Stage 1 Road Safety Audit

Cloghercor Wind Farm, Co Donegal

On behalf of Cloghercor Wind Farm Ltd.

3.2.3 Site Access 1 and 2 – Carriageway drainage

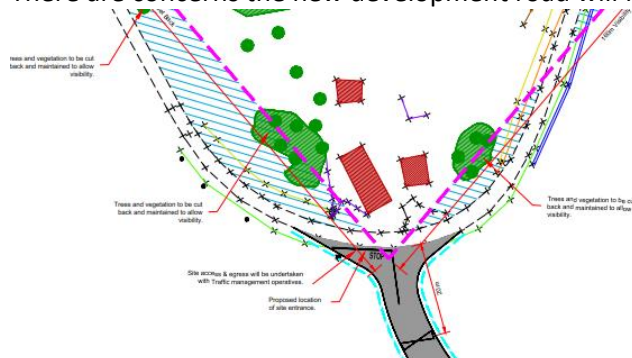
Problem: No drainage details have been provided. The construction of the access roads may result in additional surface water being routed to the public road, or impact with the existing road drainage system.

Hazard: Loss of control type collisions may result.

Recommendation: Ensure adequate surface water drainage is provided.

3.2.5 Site Access 1 – Swept Path

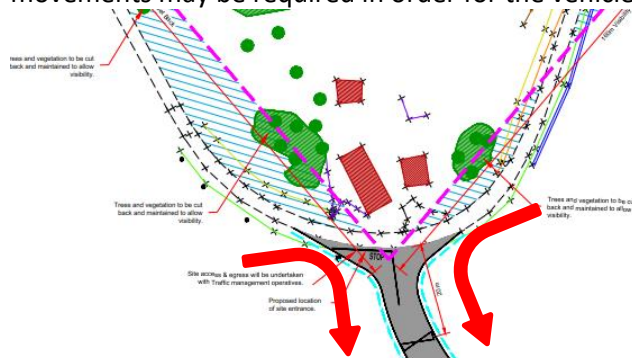
Problem: The audit team have been advised that turbine delivery will be via Access Location 1 only. The junction geometry appears tight for passage of long vehicles. Multiple forward / reverse movements may be required in order for the vehicle to access the new road.

Hazard: Impact with following traffic may result.

Recommendation: Ensure a suitable junction geometry is provide for access of delivery vehicles.

3.3.1 Road Widening Fig 16.8

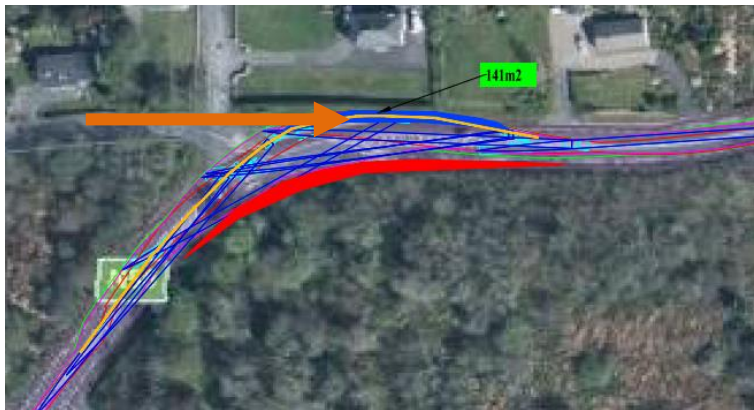
Problem: The proposed widening on the National Road is in the area of the L5465 local grade road. At present the grassed verge assists in forcing vehicles exiting the location road to align right angles with the National Road.

Hazard: The removal of this verge / replacement with hardstanding may result in overshoot type collisions with National Road traffic.

Recommendation: Ensure adequate physical measures are retained / installed to ensure local road traffic both yield to the national Road users and also at a suitable angle, where approaching vehicles from both direction can be observed with ease.

Fig 16.22

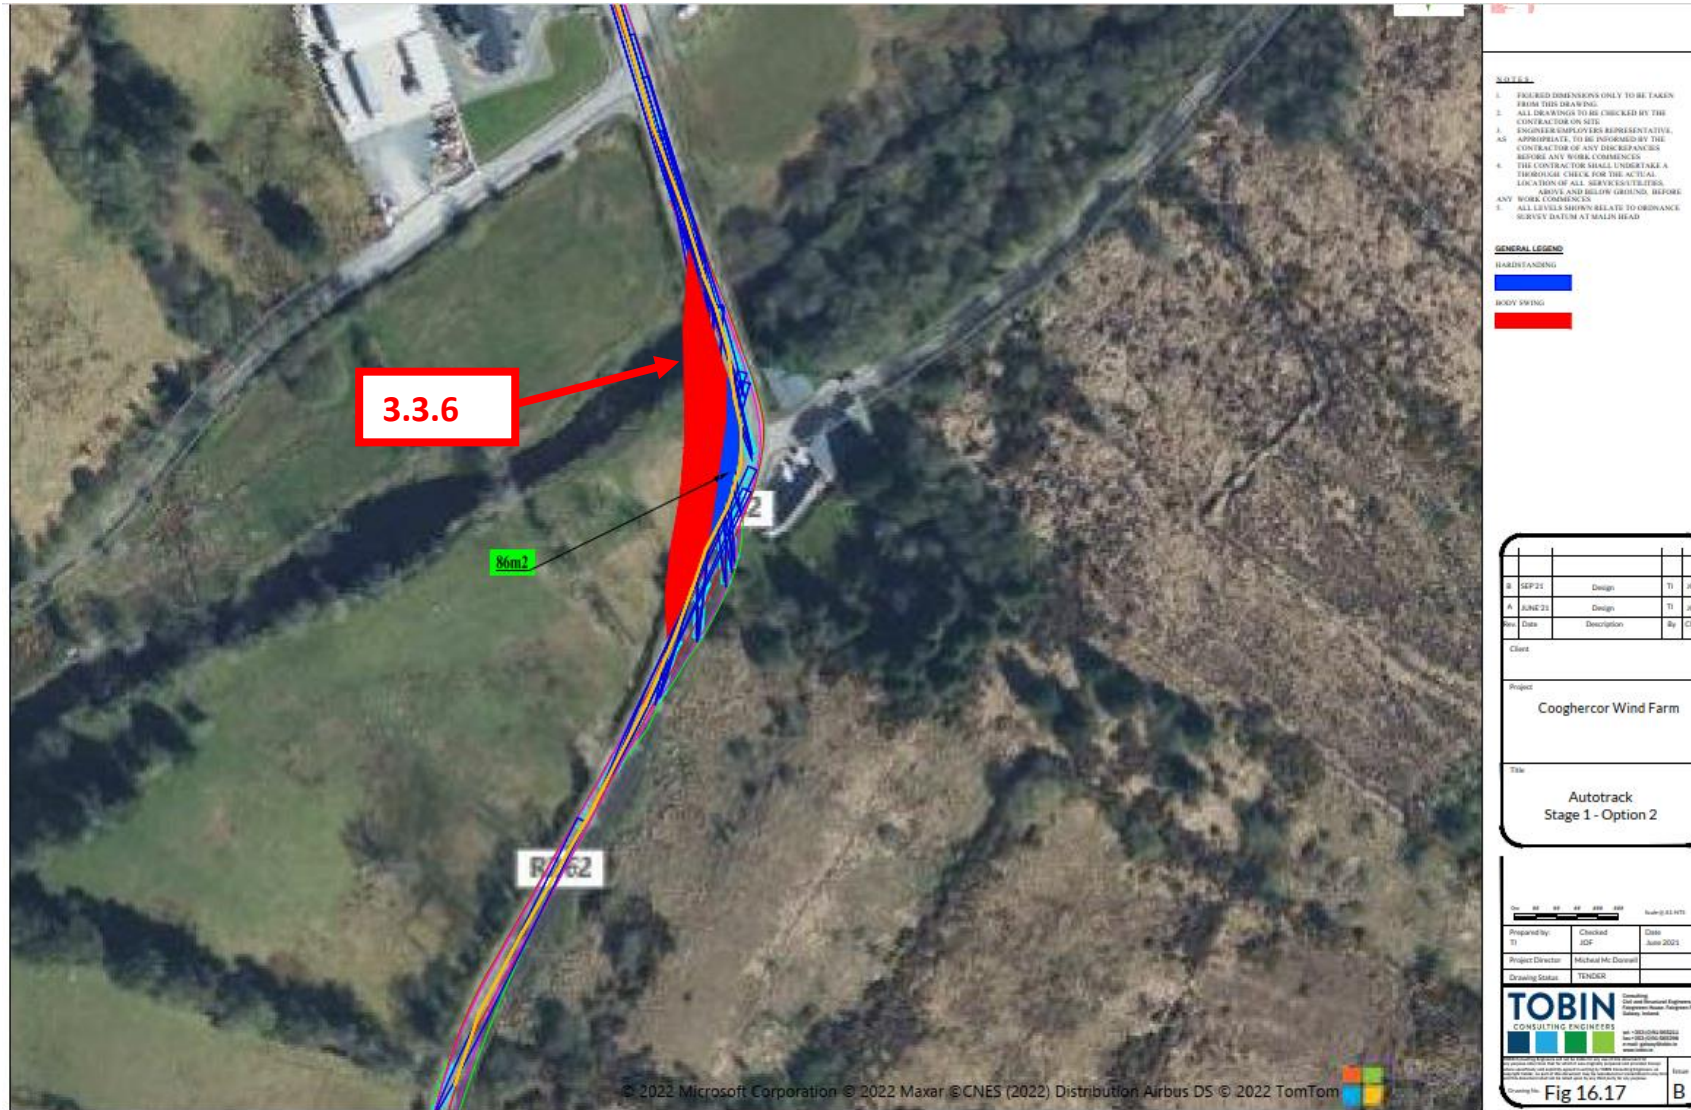
Problem: The set down area is located just to the south of a crest curve on the Regional Road. Long and slow moving vehicles, in the process of crossing the Regional Road in order to access the set down area, may not be seen by southbound Regional Road traffic.

Hazard: Impact between the southbound public road user and the development vehicle may result.

Recommendation: Ensure the set-down area is provided where adequate forward visibility can be achieved.

Sheet: B
Drawing No: Fig 16.15

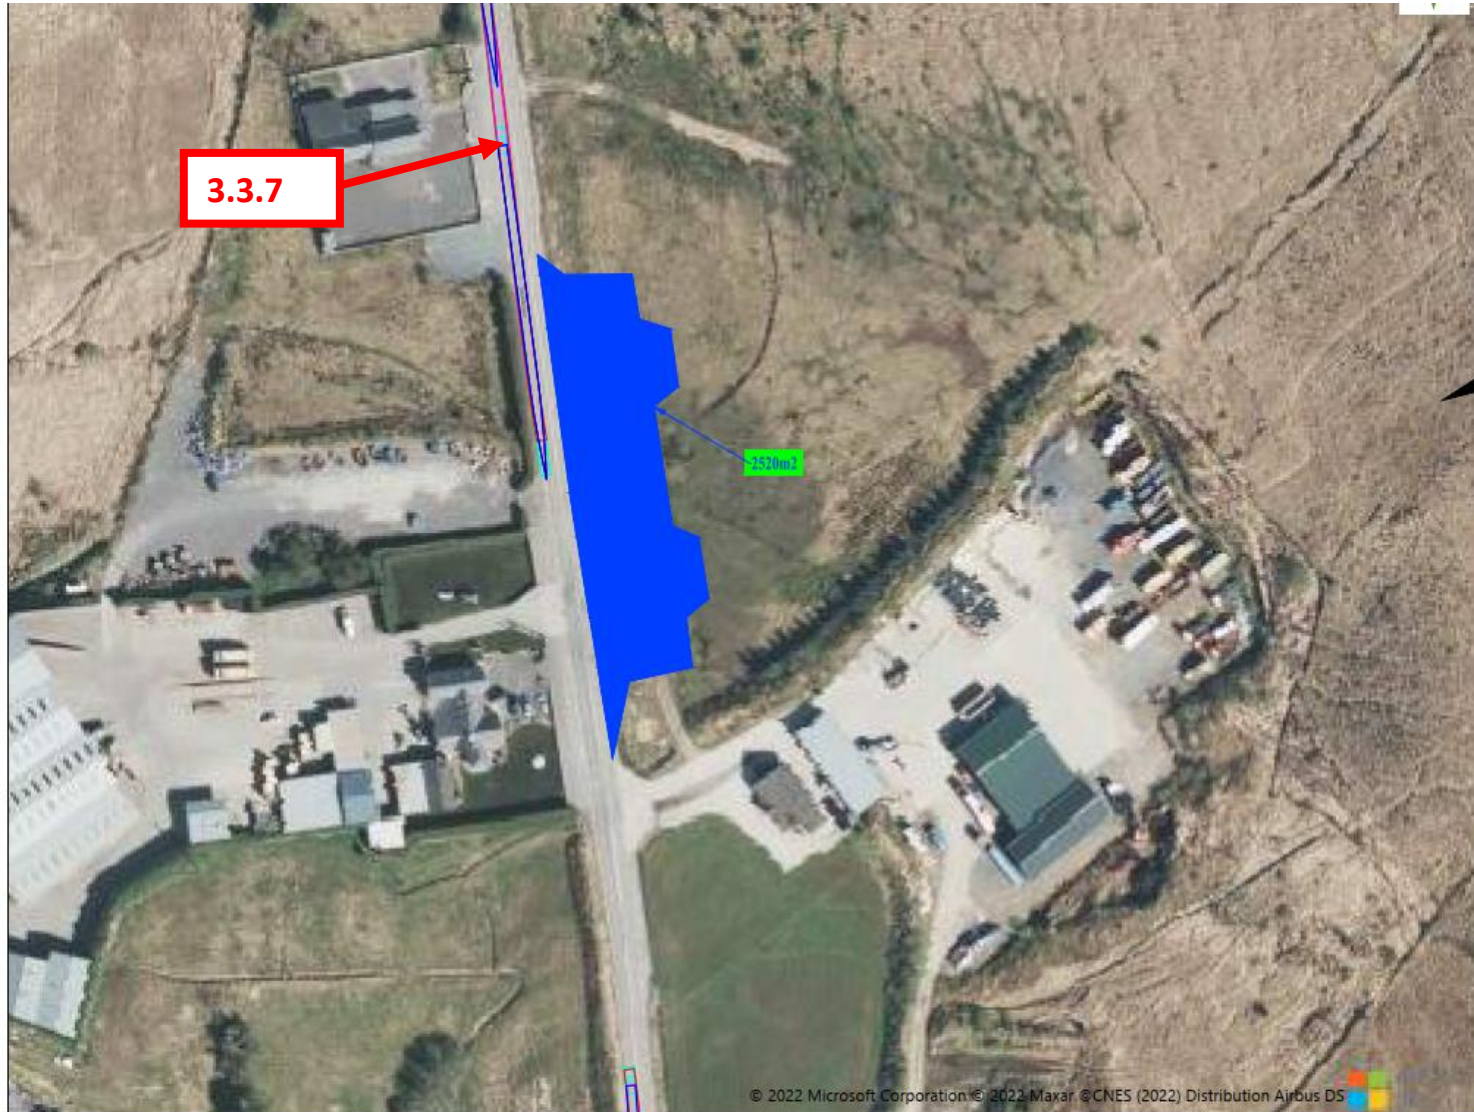
Problem: The lands to the west of the proposed road widening fall away from the road at a steep gradient. Currently the fall is protected by a vehicle restraint barrier. The barrier will need to be removed for passage of the turbine delivery vehicles.

Hazard: Errant motorist may traverse the road widening and overturn on the steep gradient.

Recommendation: Ensure suitable vehicle restraints are provided wherever the gradient is within the carriageway clear zone. Furthermore, ensure the anticipated angle of impact is suitable for the performance of the barrier.

Problem: Existing chevron signs are located in the area of the proposed road widening. Removal / relocation of the chevron signs may lessen the impact of the sign to the motorist.

Hazard: Users may attempt to drive around the bend at excessive speed. Loss of control collisions may result.

Recommendation: Ensure suitable warning of the bend is provided to the road user at all times, even when component deliveries are scheduled.
